ENGINE SYSTEMS, INC.

Subject: 10CFR21 Reporting of Defects and Non-Compliance -
Engine Systems, Inc. Report No. 10CFR21-0104, Rev. 0

NPPD Fuel Hose, P/N 2-01H-050-003

10CFR21 REPORTING OF DEFECTS AND NON-COMPLIANCE

FIGURE 1
FUEL HOSE #2-01H-050-003

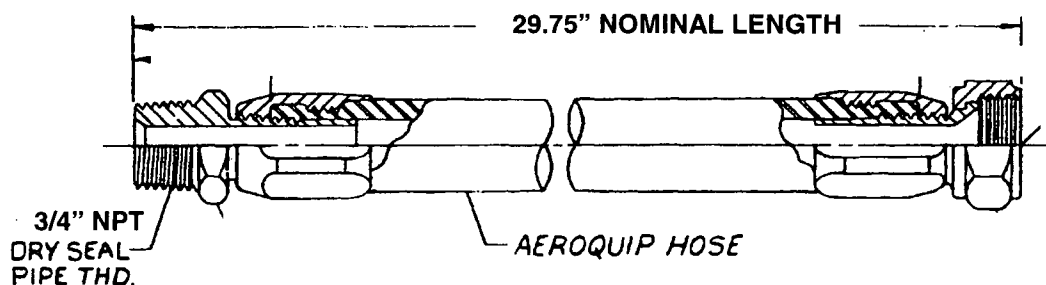
The foreign material found during inspection of the returned hose assembly was determined to be very small pieces of the elastomer tube internal to the hose. It appears these pieces were introduced during assembly of the end fittings onto the hose during fabrication of the hose assembly.

The hose, P/N 2-01H-050-003, is located after the engine fuel filter and before the fuel injection pumps. Foreign material within this hose could migrate to the fuel injection pumps. The entrance of foreign material could impact operability of one or more fuel injection pumps and therefore affect fuel delivery to one or more engine cylinders. This could impact the load carrying capability of the diesel engine or possibly complete engine shutdown. Either scenario has the potential to prevent the emergency diesel generator from performing its safety related function.

This hose is used in the fuel oil supply piping on the KSV diesel engine; it is located in the piping between the engine fuel filter and the fuel injector pumps (see Figure 1 and 2) and is unique to the NPPD-Cooper Station engines.

Hoses remaining in customer inventory should be inspected to verify they are free of foreign material prior to installation. Any hoses previously installed on the EDG are not suspect as operability has been confirmed via functional testing.

To prevent recurrence of this issue, the dedication report for the hose assembly has been revised to include a requirement to solvent flush each hose prior to shipment. Filtered solvent will be pumped through the hose for a minimum of 5 minutes. After flushing, nitrogen will be blown through the hose to remove excess flushing fluid and a detailed visual inspection will be performed to ensure there are no visible contaminants immediately prior to installation of the hose end caps. This flushing requirement was already included in the dedication reports for other critical application hose assemblies so this notification is being limited to this part number only.
